Shearon Harris Nuclear Power Plant, Unit 1  
Docket No. 50-400/Renewed License No. NPF-63

Subject: Cycle 21 Core Operating Limits Report, Revision 1

Summary of Changes – HNP Cycle 21 Core Operating Limits Report Revision 1

Cycle 21  
Core Operating Limits Report  
Revision 1

Figure 7, Reactor Core Safety Limits – Three Loops in Operation

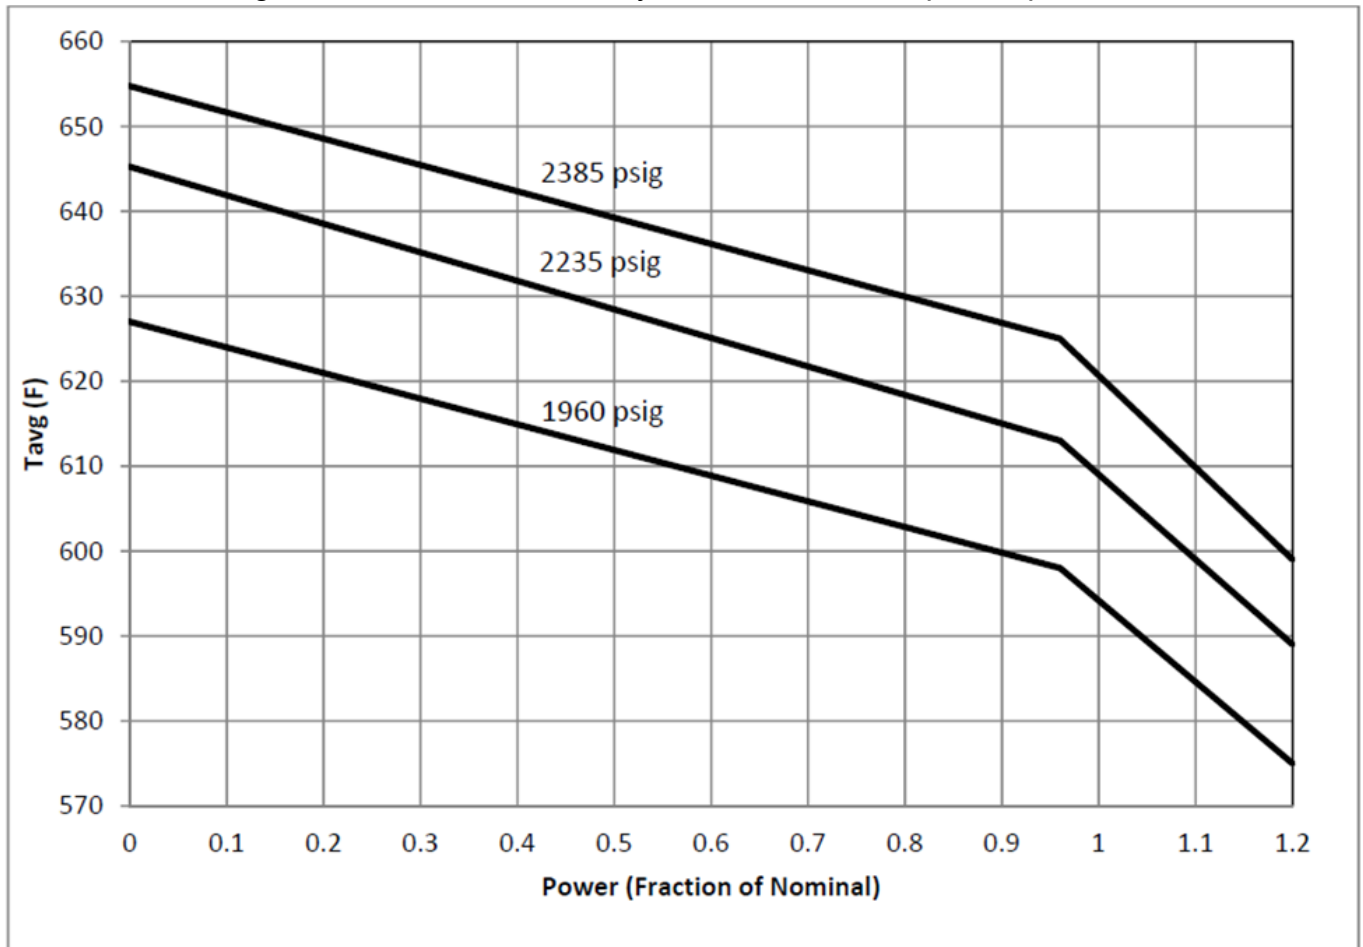
Figure 7	Added New Figure: Reactor Core Safety Limits – Three Loops in Operation. Relocated from TS per Facility Operating License Amendment No. 161. Added table with corresponding data points.

Data Points for Figure 7		
Pressure (psig)	Power Fraction	Tavg (°F)
2385	0.00	654.75
	0.96	625.00
	1.20	599.00
2235	0.00	645.25
	0.96	613.00
	1.20	589.00
1960	0.0	627.00
	0.96	598.00
	1.20	575.00
